MFN 06-262
Supplement 4

Subject: **Modified Reactor Building/Fuel Building Truncated Model,
SER-ESB-038 Rev. 5**

**Shimizu Engineering Report SER-ESB-038, Rev. 5,
“Modified RBFB Truncated FE Model Analysis Data,”**

Project	General Electric Company ESBWR Project	Shimizu Document No.	SER-ESB-038
Title	Modified RBFB Truncated FE Model Analysis Data	Rev.	5
		Issued Date	9/22/06
		Revised Date	1/9/07

Figure C-13 Element Forces Comparison NASTRAN to ANSYS (R7 F1 Wall: Axial Force [MN/m])

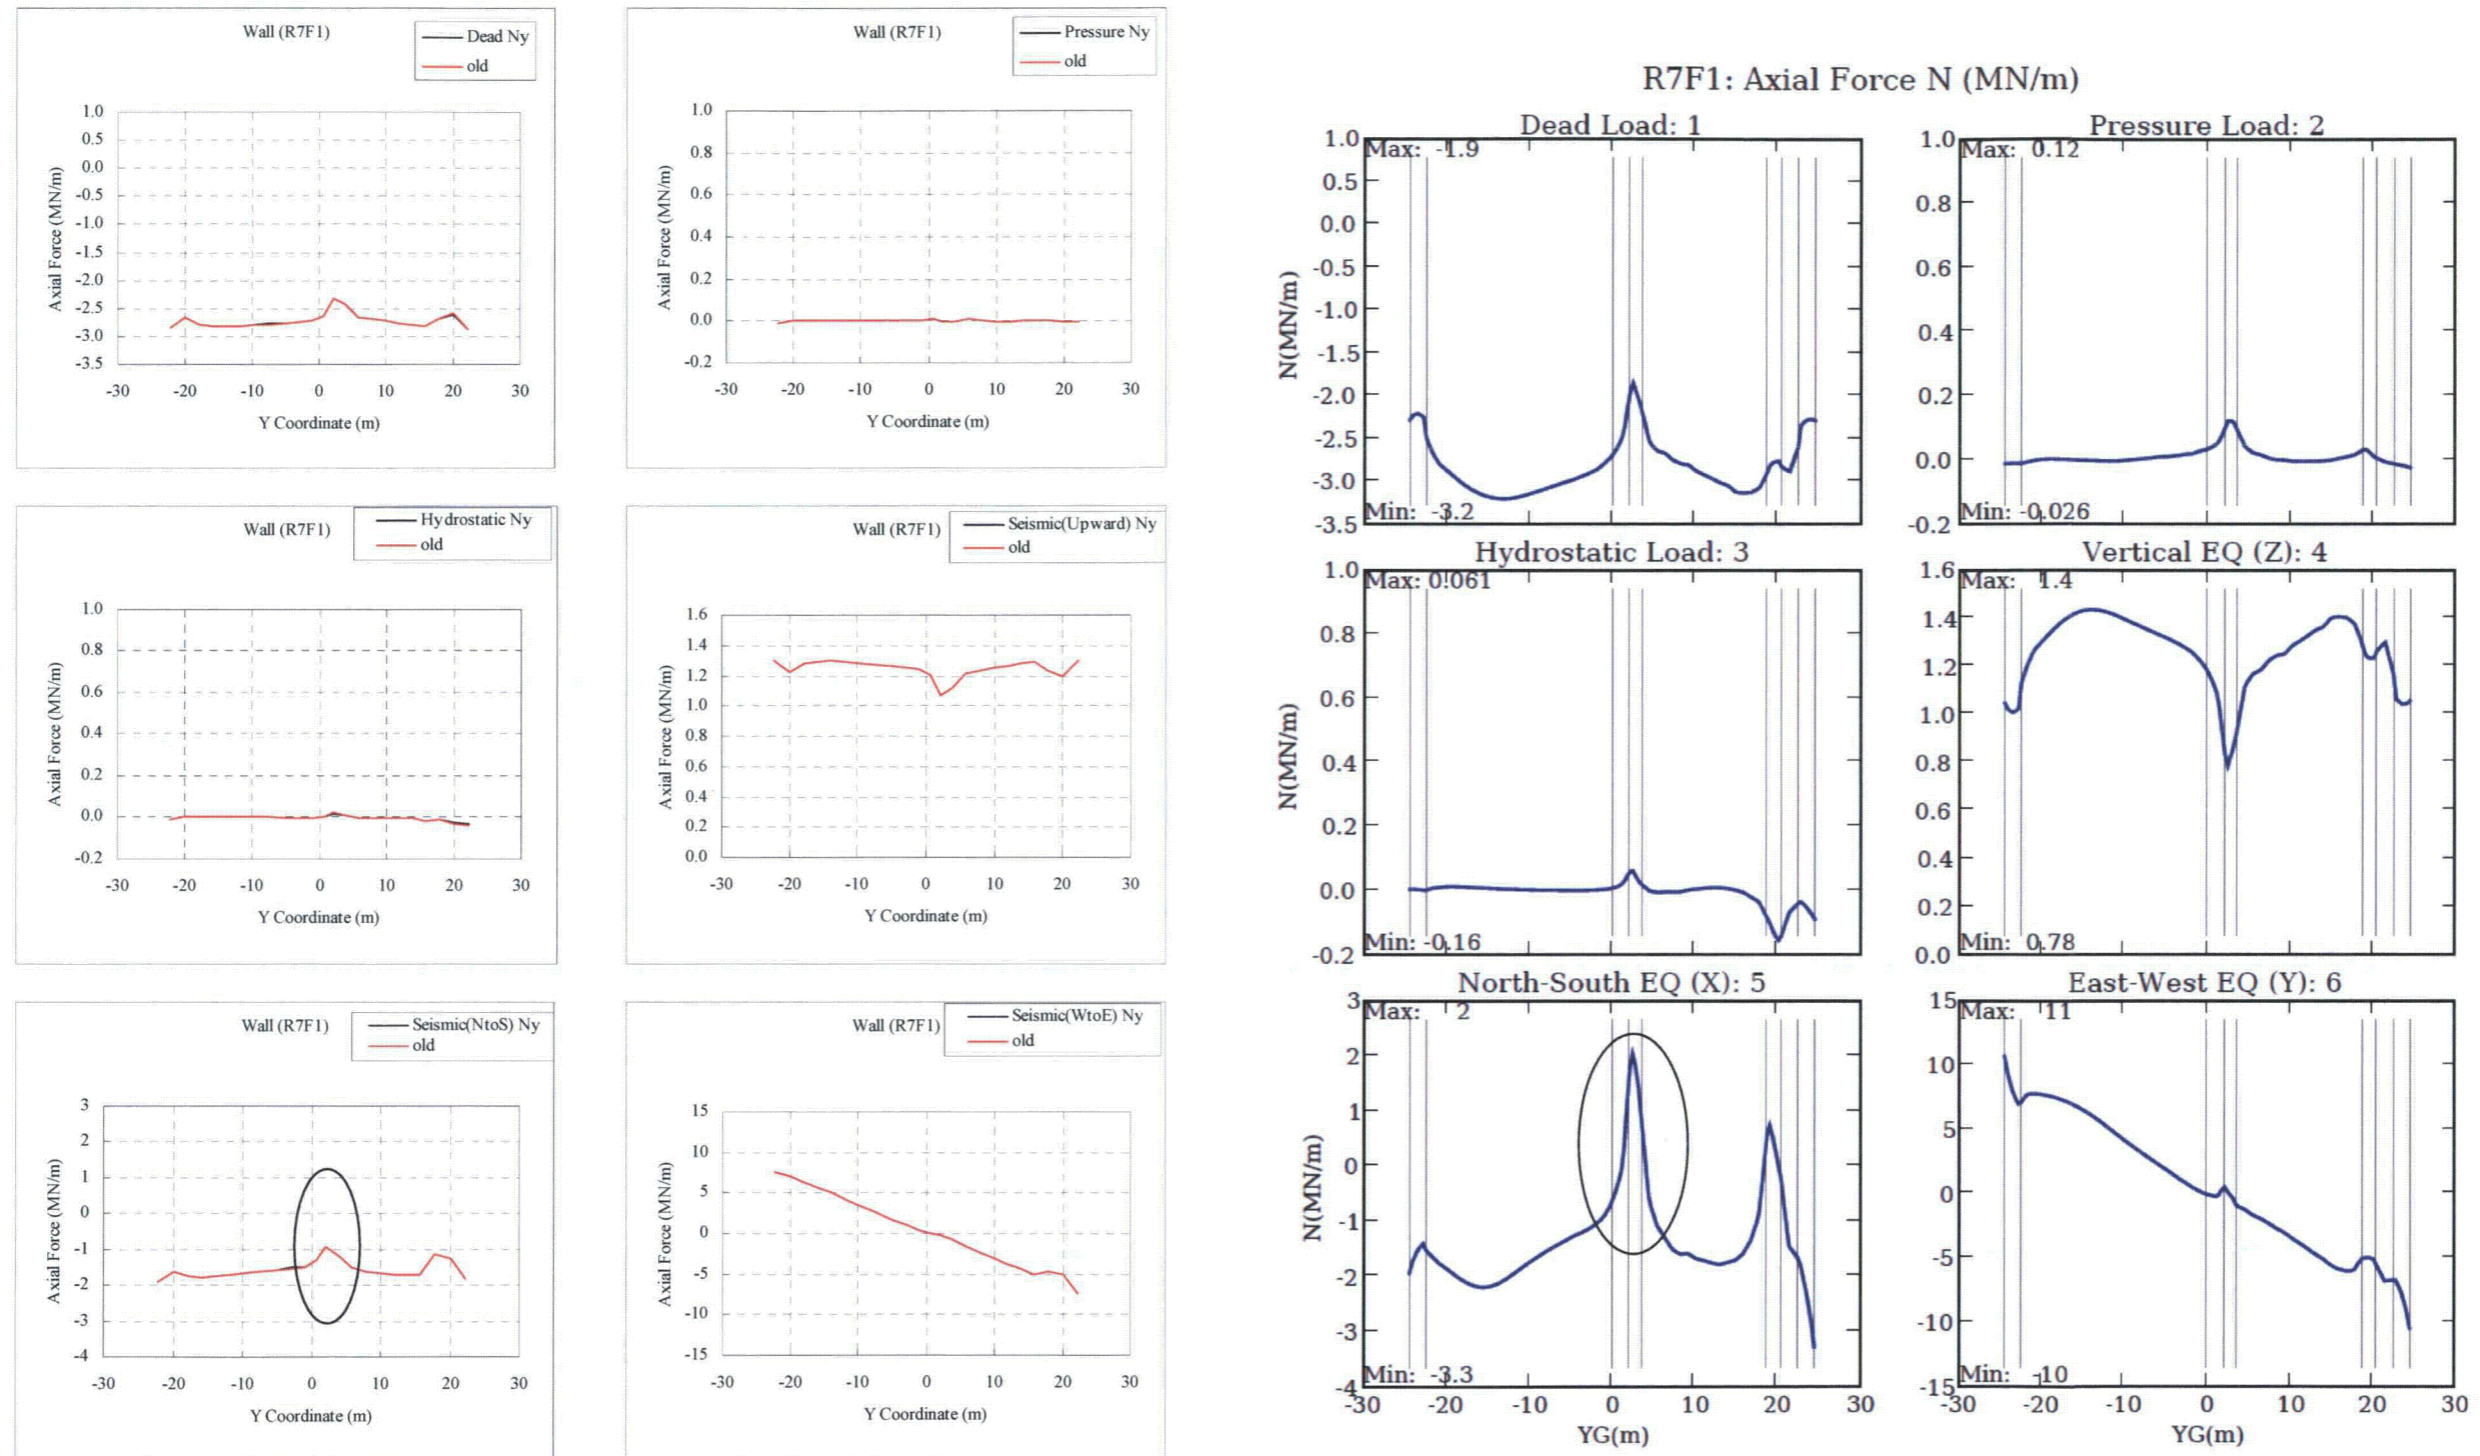
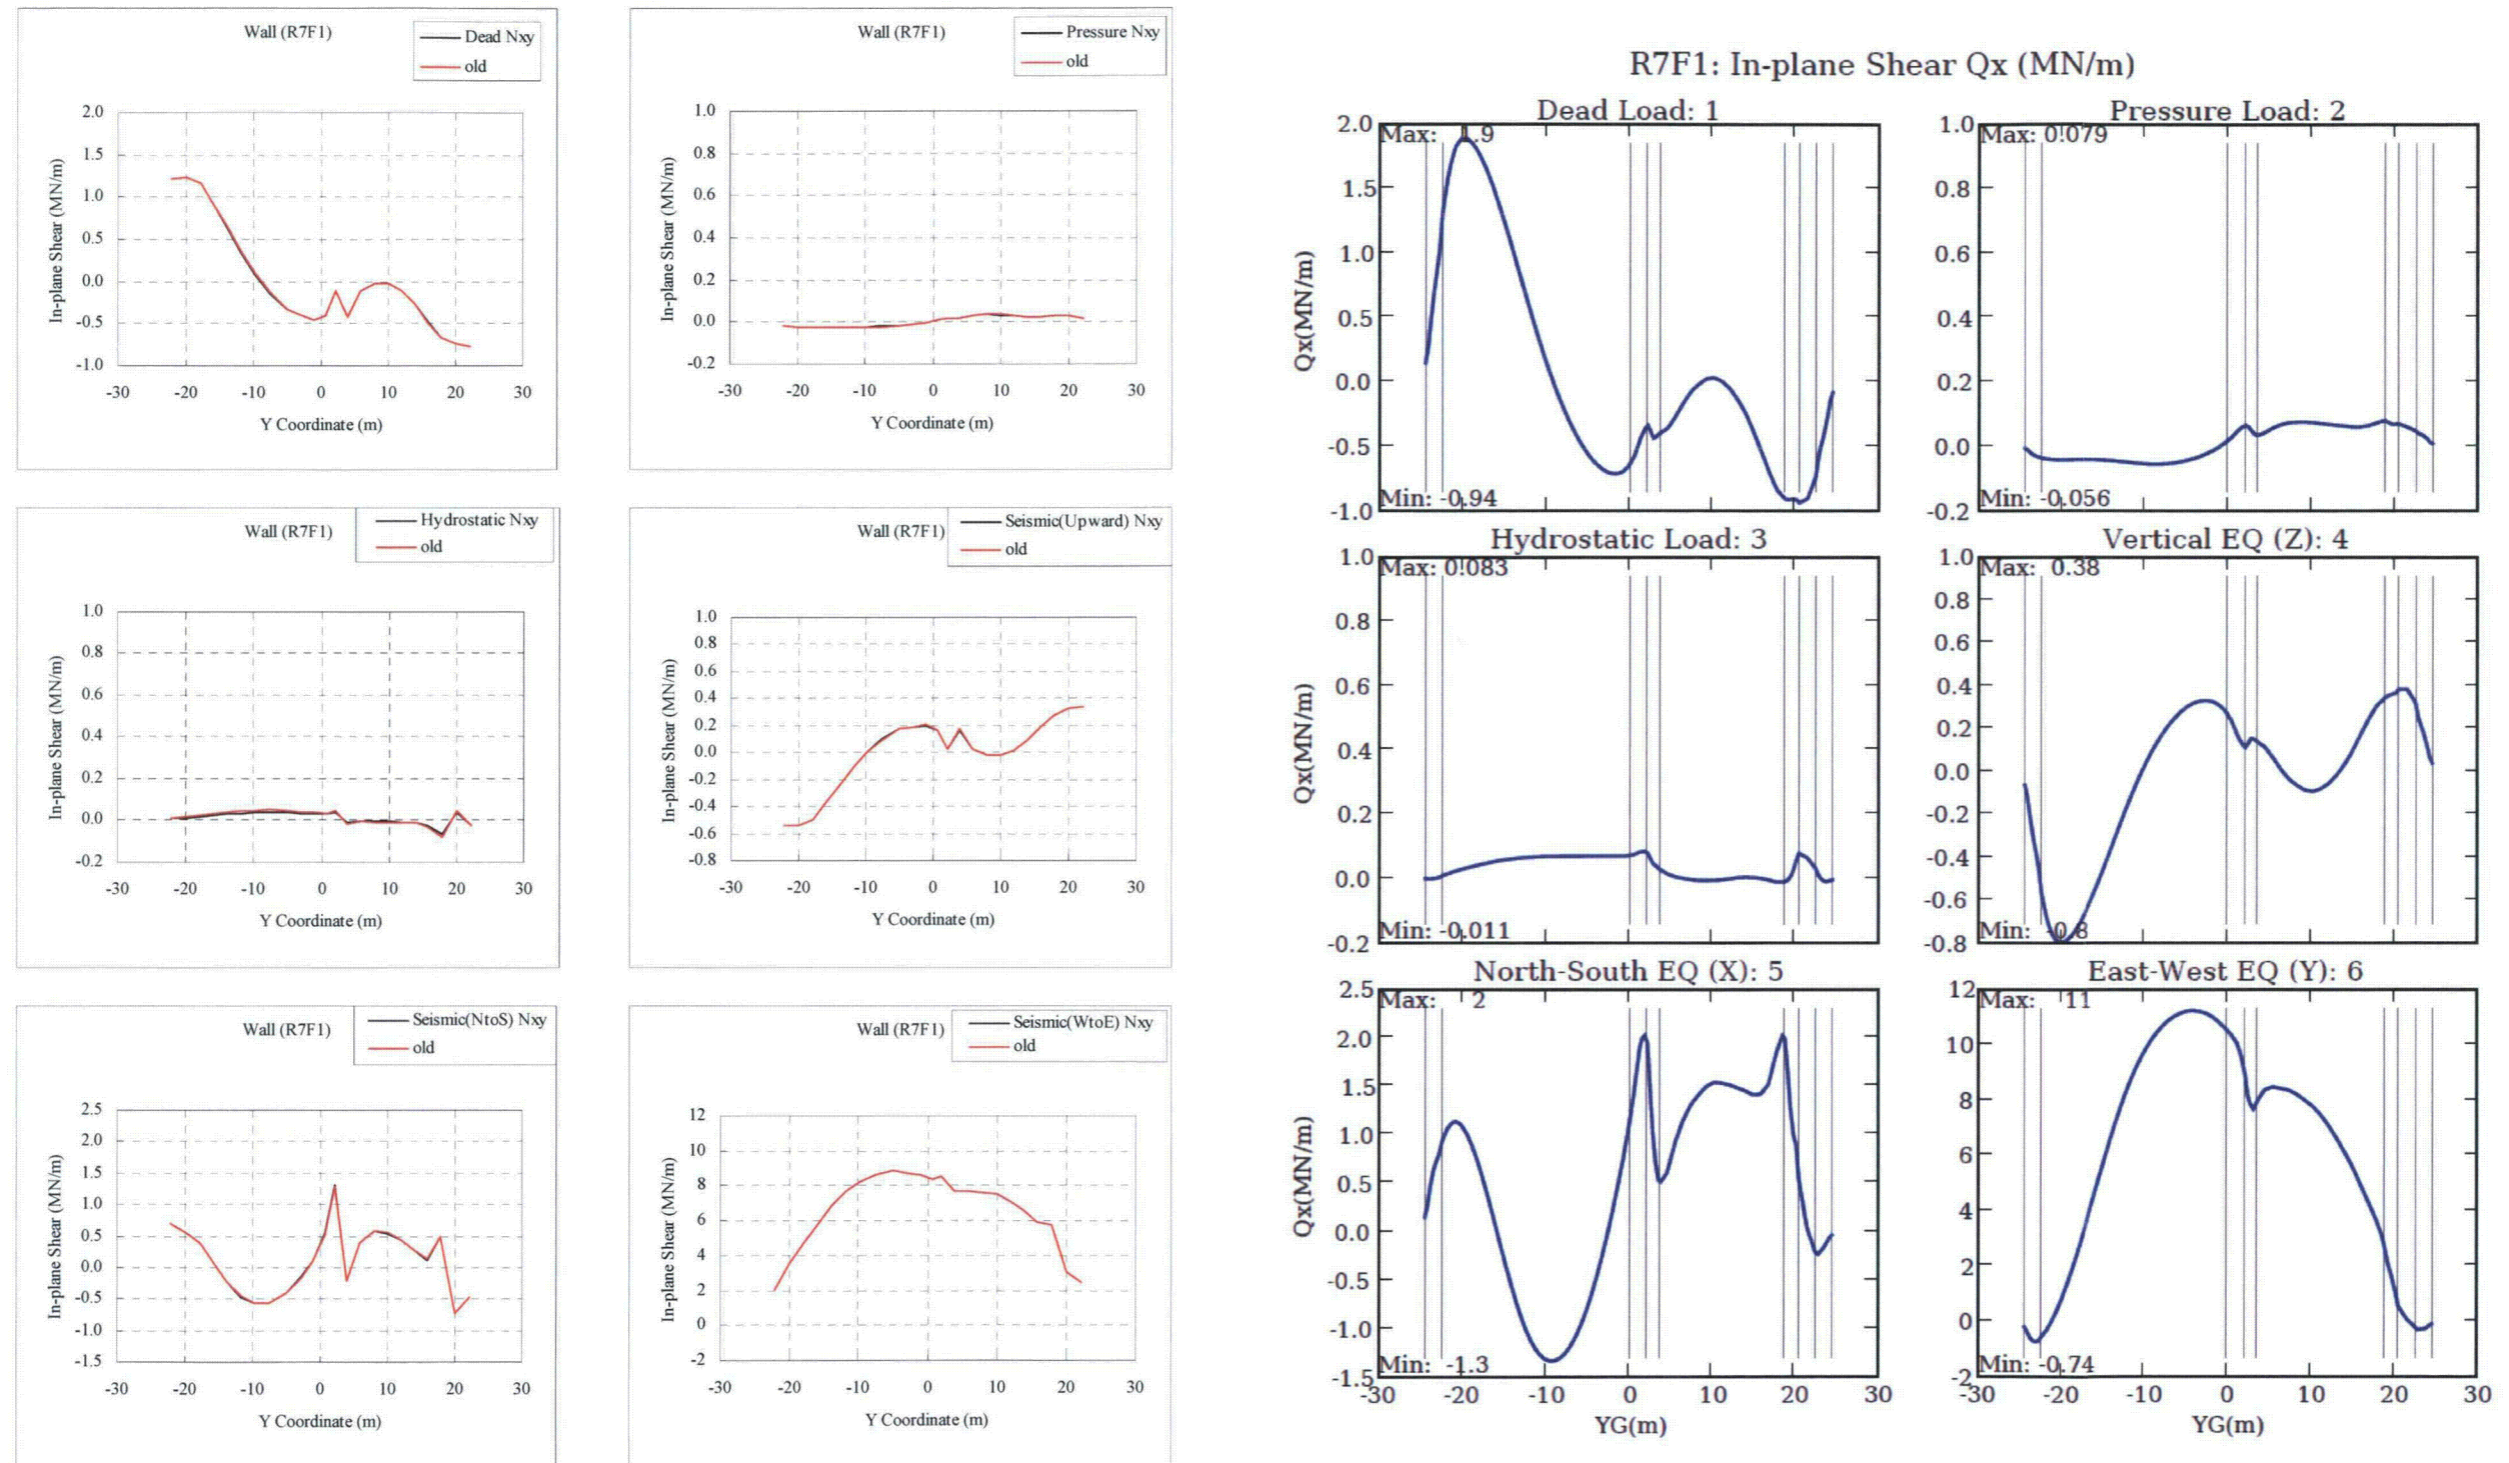
- iii) *The differences of magnitude of forces appeared on basemat inside pedestal:* The result of re-analysis using the updated model shows better agreement. In case of seismic load the magnitude of forces has to be re-compared because BNL's soil spring may not be adequate as pointed out above 3).

- iv) *The differences of magnitude of forces appeared on outer wall of Fuel Storage Pool (FSP):* For the out-of-plane shear forces and moments on RA and F3 wall located around FSP in case of Hydrostatic load, BNL's results are lower than those of GE. GE assumes the some part of differences comes from the difference of estimation levels between both models as pointed out above 8). In order to have a better understanding of the differences, GE would like to request BNL to confirm the input data for Hydrostatic load.
